WATERBURY FILING NO. 1 EL PASO COUNTY, CO CONSTRUCTION SET FEBRUARY 2023

EPC STORMWATER REVIEW COMMENTS IN ORANGE BOXES WITH BLACK TEXT

**NORTH CONCRETE FOREBAY**  
SCALE: 1"=10'

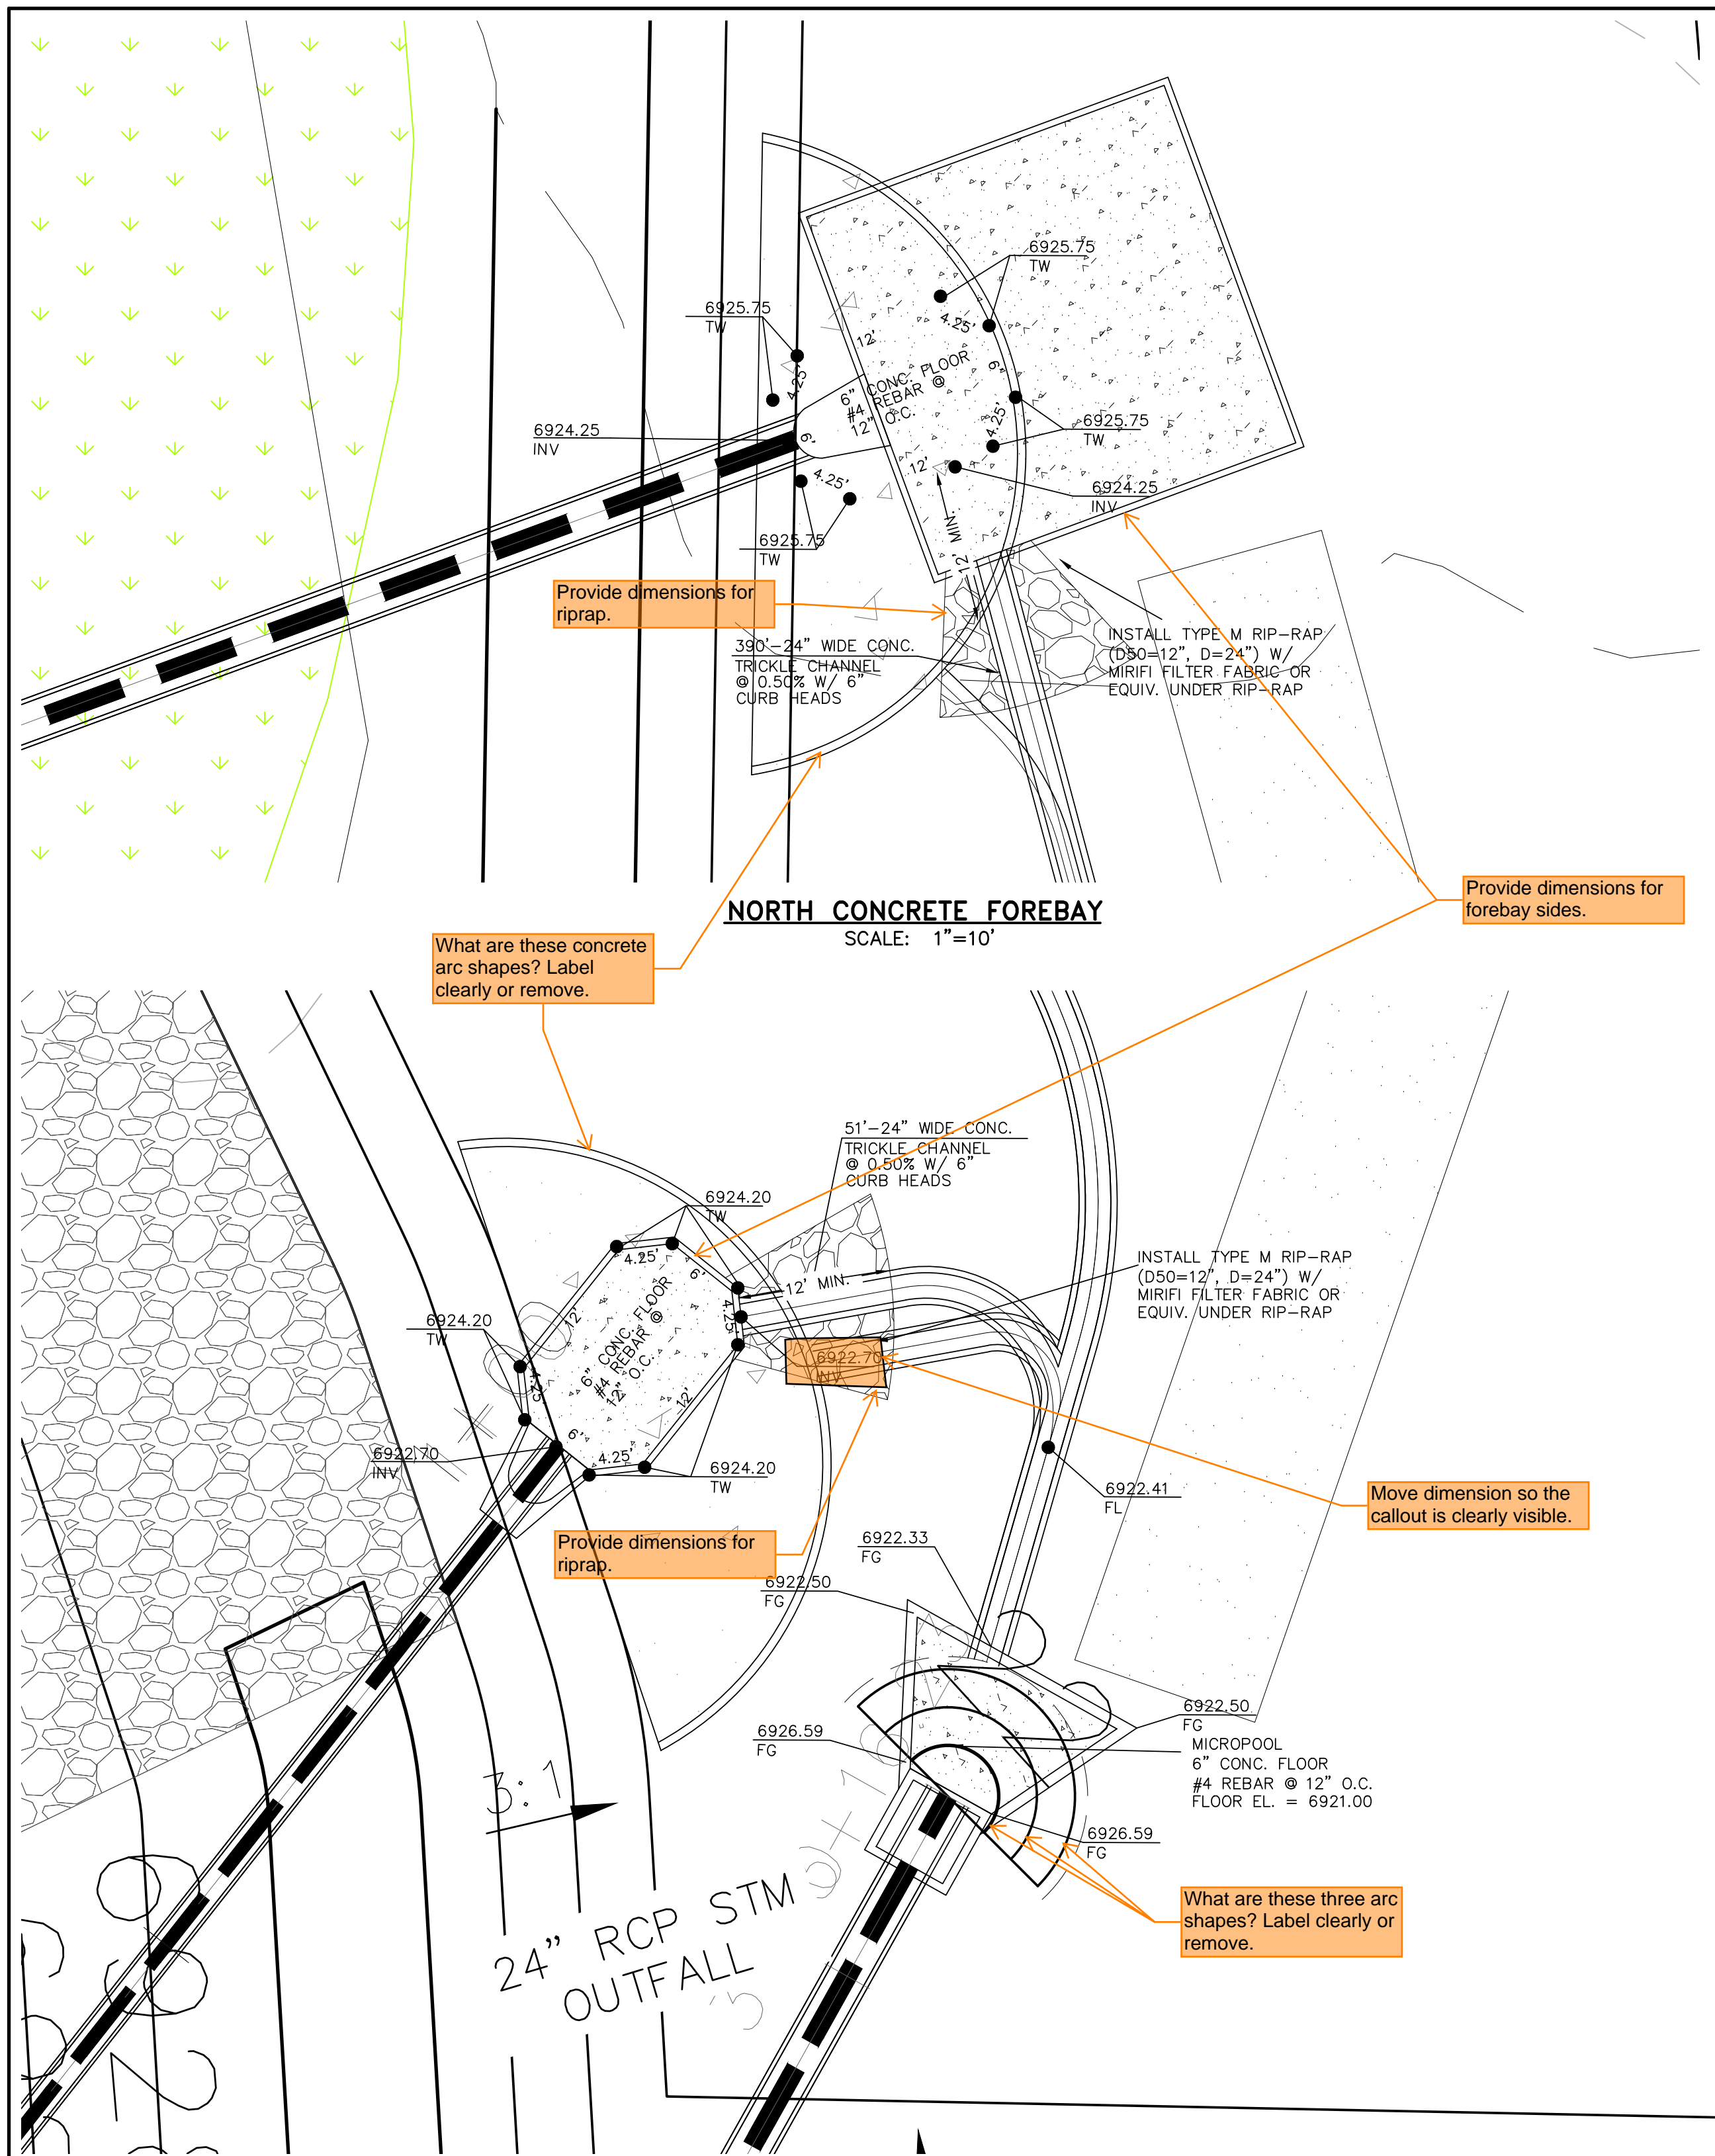
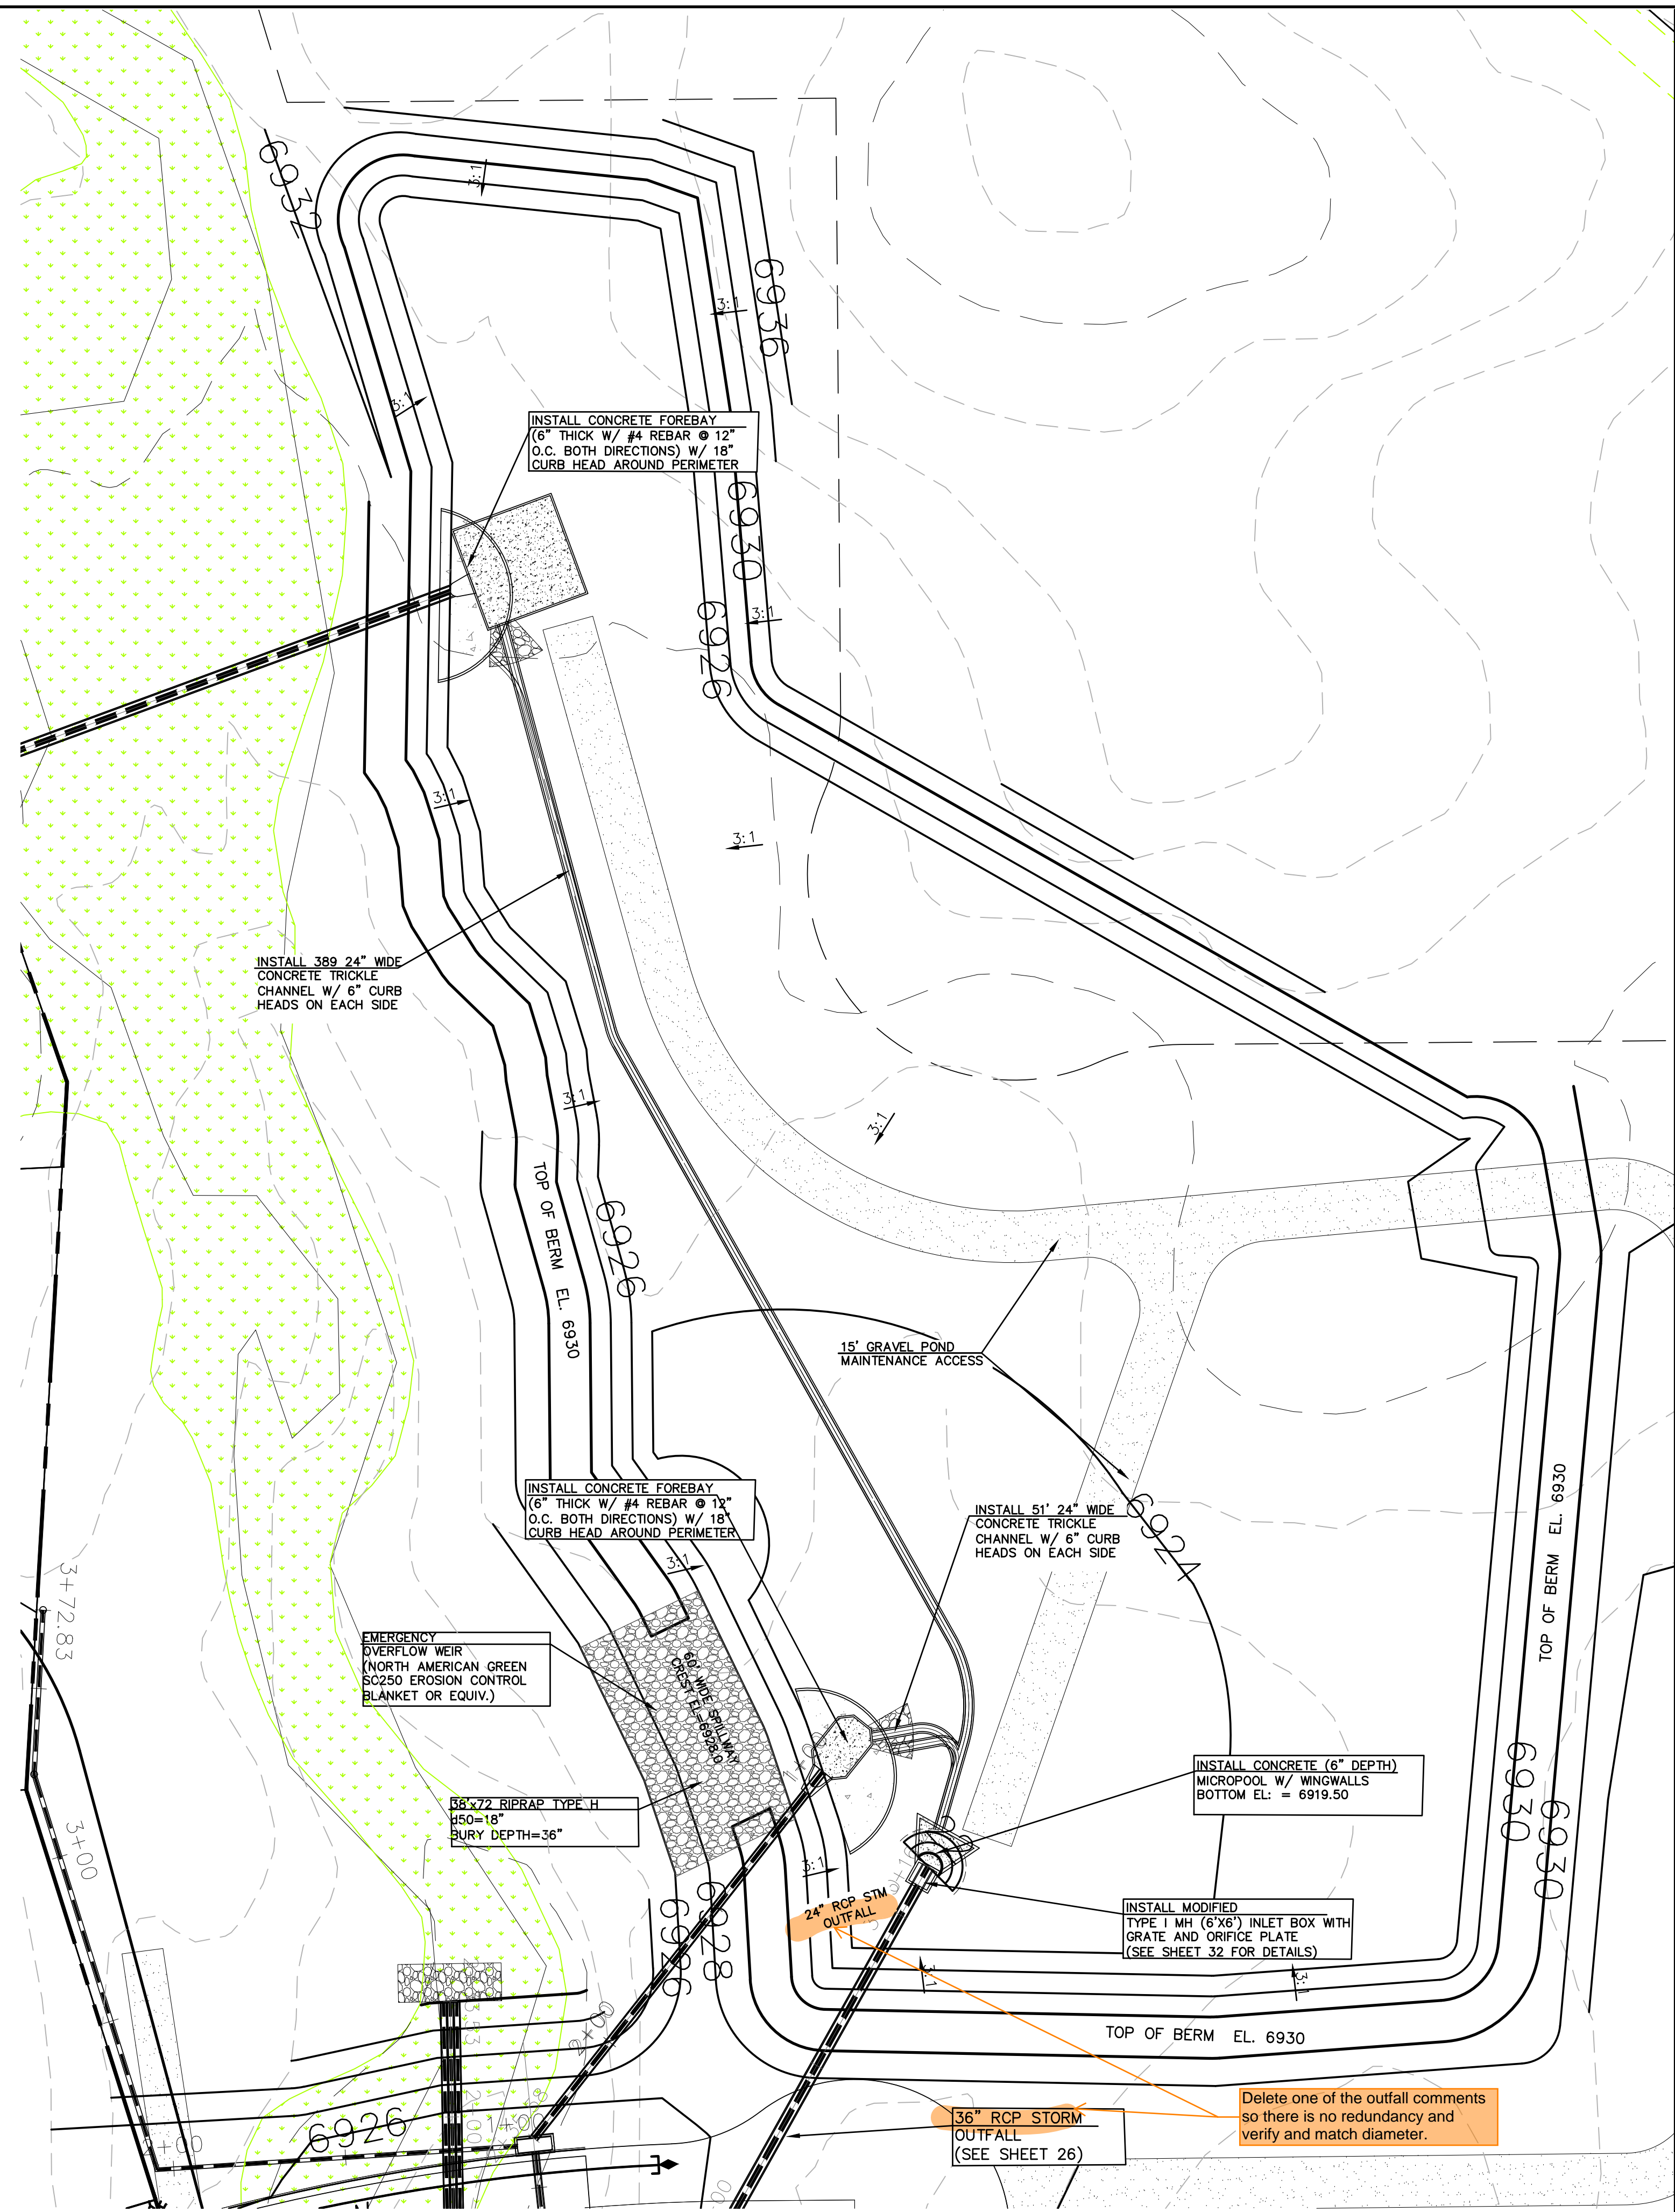
Provide dimensions for riprap.

What are these concrete arc shapes? Label clearly or remove.

Provide dimensions for forebay sides.

Provide dimensions for riprap.

What are these three arc shapes? Label clearly or remove.

Remove "east." That is a carryover from Pond 1 that doesn't apply to Pond 3

Does not match the DR. Verify and update so both match.

Delete one of the outfall comments so there is no redundancy and verify and match diameter.
